Technical Service Bulletin: tsb100204

LTA Junction Block Pipe Support Brace.

New LTA junction block support bracket with pipe support brace.

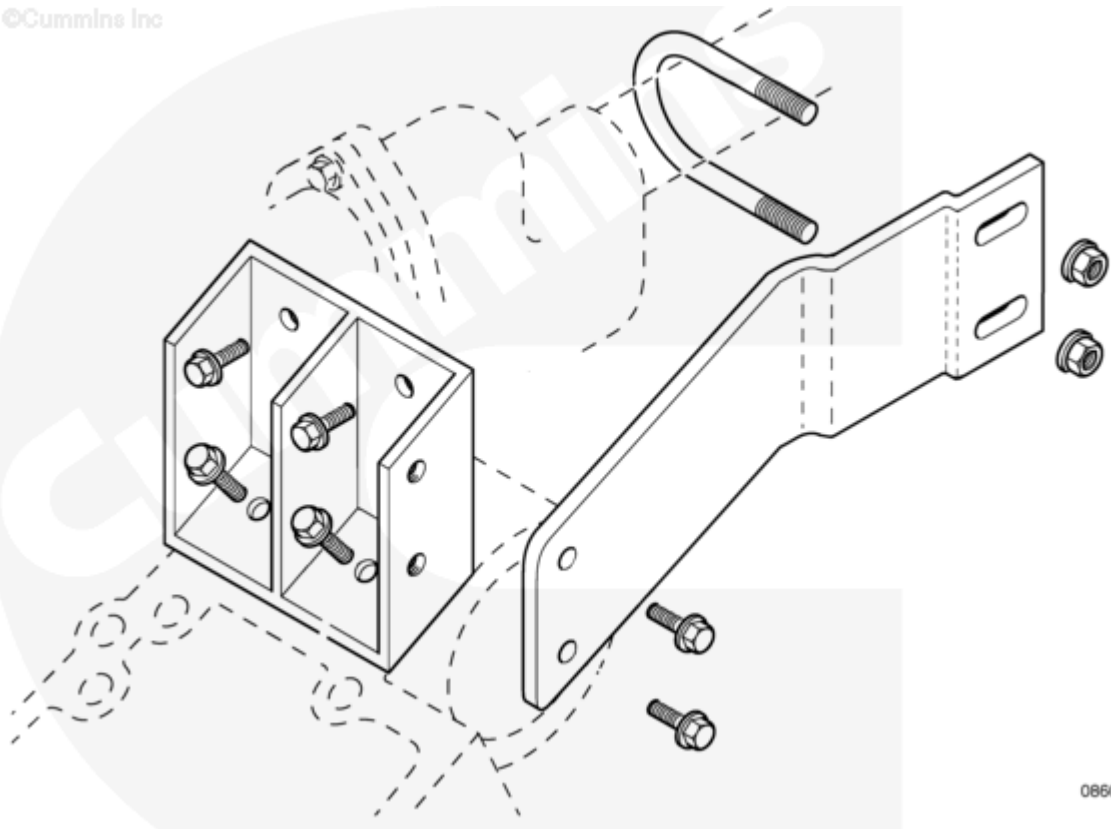
The purpose of this topic is to inform the field of the introduction and of an LTA (Low Temperature Aftercooler) pipe support brace, designed to help prevent water leakage from the LTA junction block located on the left bank Number 1 rocker housing on QSK45/60 engines. The junction block bracket has been stiffened to improve its rigidity, and a brace and U-bolt clamp has been incorporated to improve the pipe to junction block joint integrity.
